EMAIL REGARDING REGULATORY REVIEW AND APPROVAL OF FIELD TASK
MODIFICATION REQUEST FOR SITE 3 NAS CECIL FIELD FL
6/11/2012
U S EPA REGION IV

**NAS Cecil Field
OU8, Site 3
EPA Approval of FTMR (BOA IR SAP FTMR 06)**

TETRA TECH NUS FIELD TASK MODIFICATION REQUEST FORM

SAP for Long-Term Monitoring At IR Sites
3,5,16,17,21,57, and 18, March 2011
Modification To (e.g. Work Plan)

DRAWN BY MJJ DATE 05Jun12	CONTRACT NUMBER 2267
CHECKED BY DATE COST/SCHEDULE-AREA SCALE AS NOTED	APPROVED BY DATE APPROVED BY DATE DRAWING NO. FIGURE 1
SOLAR SYSTEM LAYOUT AND SYSTEM MONITORING WELLS AND WELL POINTS OPERABLE UNIT 8, SITE 3 NAVAL AIR STATION CECIL FIELD JACKSONVILLE, FLORIDA	
REV 0

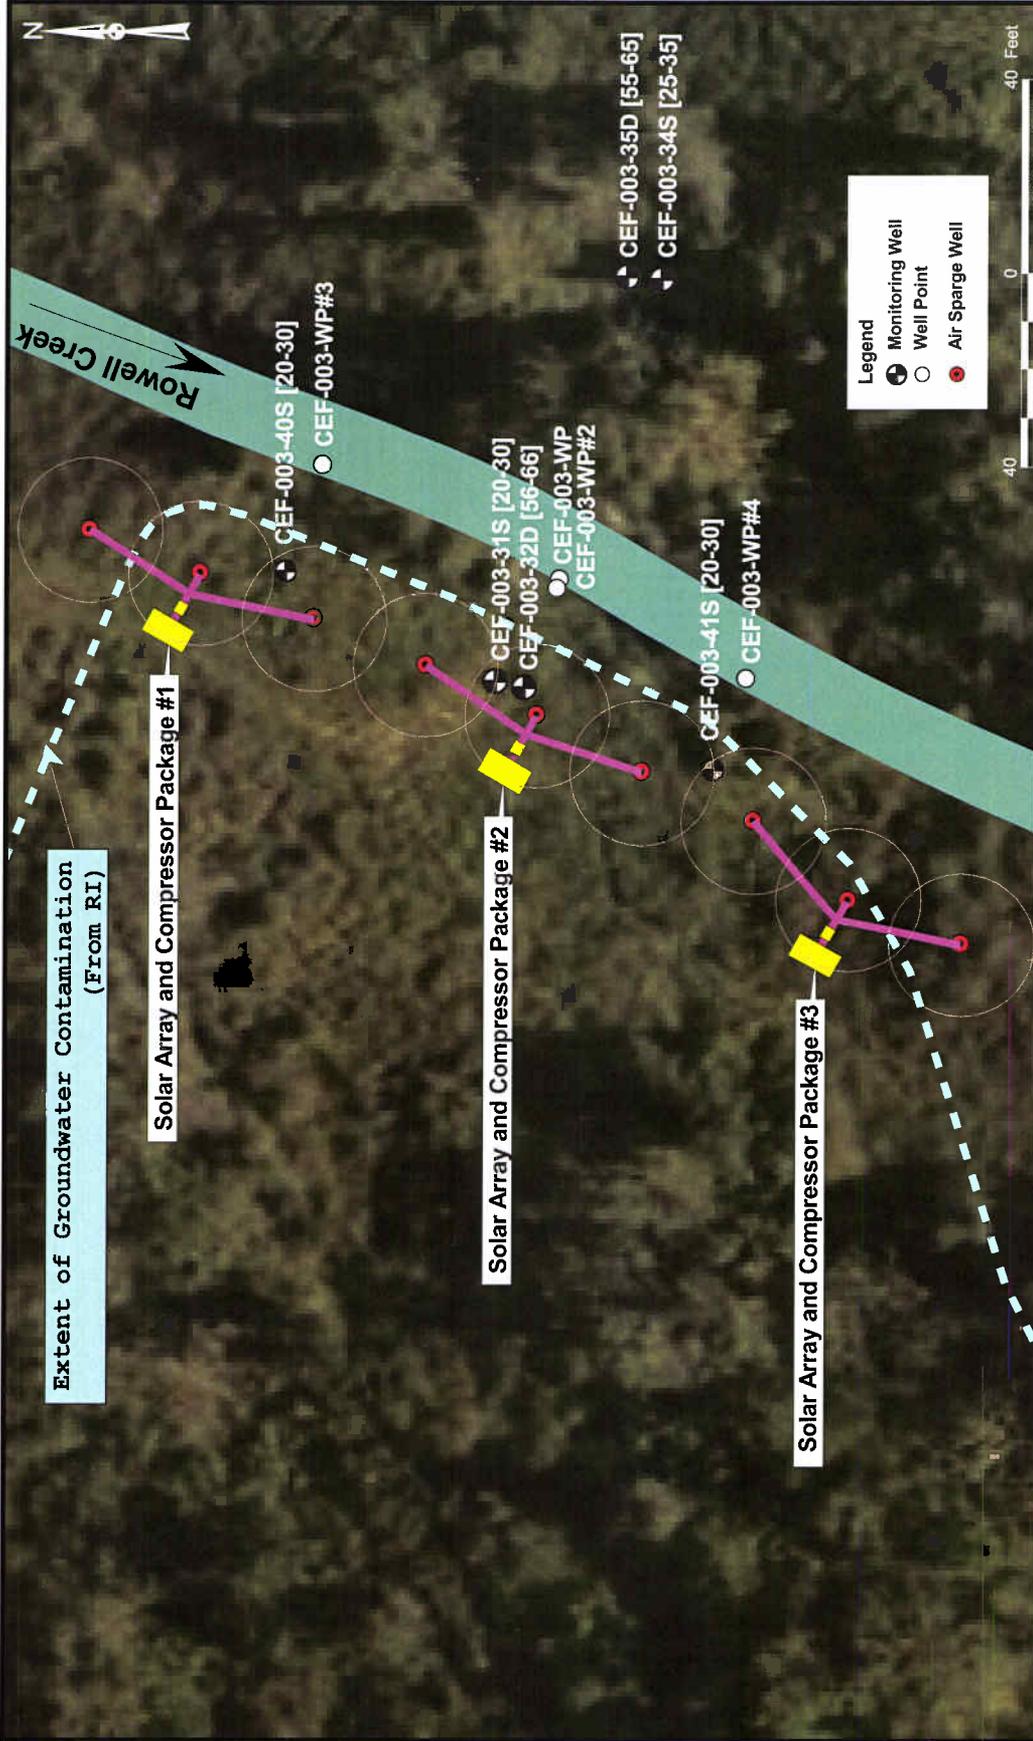
Reason for Change: Additional wells and well points were installed as part of the Pilot Study for Solar-Powered Low-Volume Air Sparging Treatment Curtain at Site 3, NAS Cecil Field, and the new wells and well points must be added to the sampling and analysis plan to ensure that contamination does not enter the creek, and to monitor the effectiveness of the system. Changes to the sampling plan are in accordance with the decision rules established SAP.
